### Evaluation of proposed move for Water Right Nos. 3424 & 6073 & 8059

Proposed: Move water right nos. 3424 & 6073 & 8059 ID4 to a new well location, 1,690 ft to the southwest.

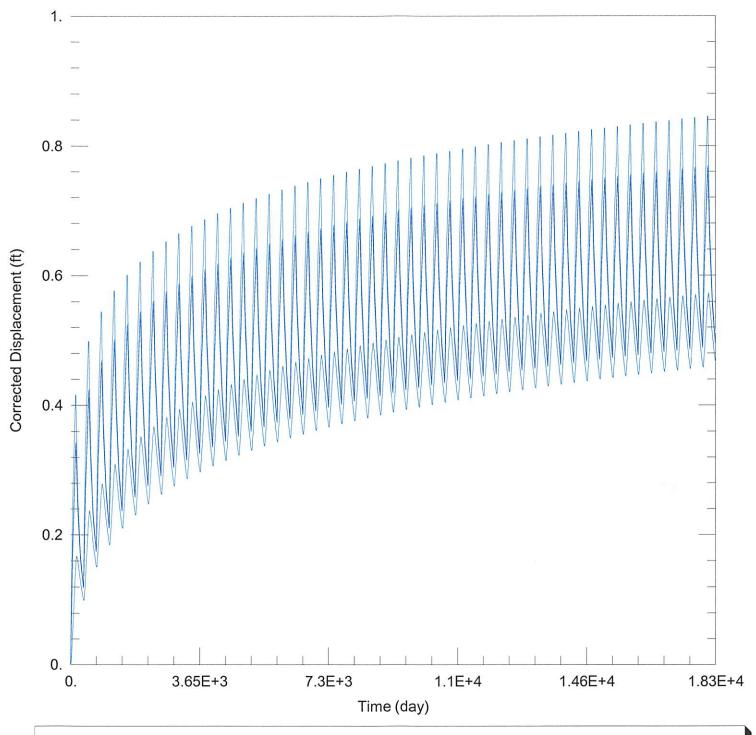
Drawdown from proposed location = 6.21 ft

Drawdown from proposed location = 5.05 ft

Drawdown from proposed location = 6.43 ft

Drawdown from proposed location = 5.46 ft

Net drawdown exceeds the drawdown allowance of 3.5 ft for all wells within 1 mile of the proposed location. Critical well analysis is necessary on those wells.

Data Set: C:\Users\trevora\Documents\2023\_moves\3424\_6073\_8059\3424 & 6073 & 8059 Current.aqt

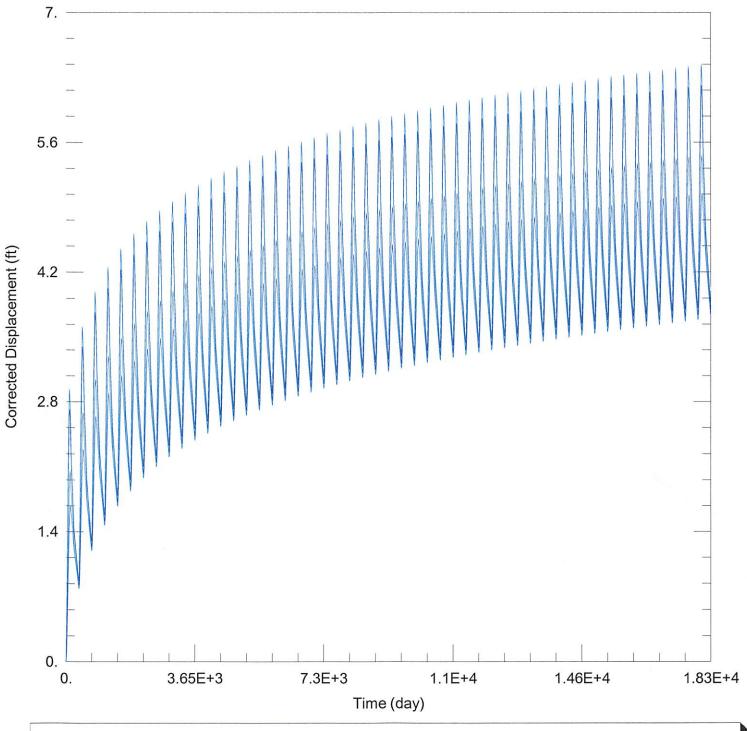
13307: Drawdown from current location = 0.77 ft

12559 & 18484: Drawdown from current location = 0.76 ft

3027: Drawdown from current location = 0.85 ft

10109: Drawdown from current location = 0.57 ft
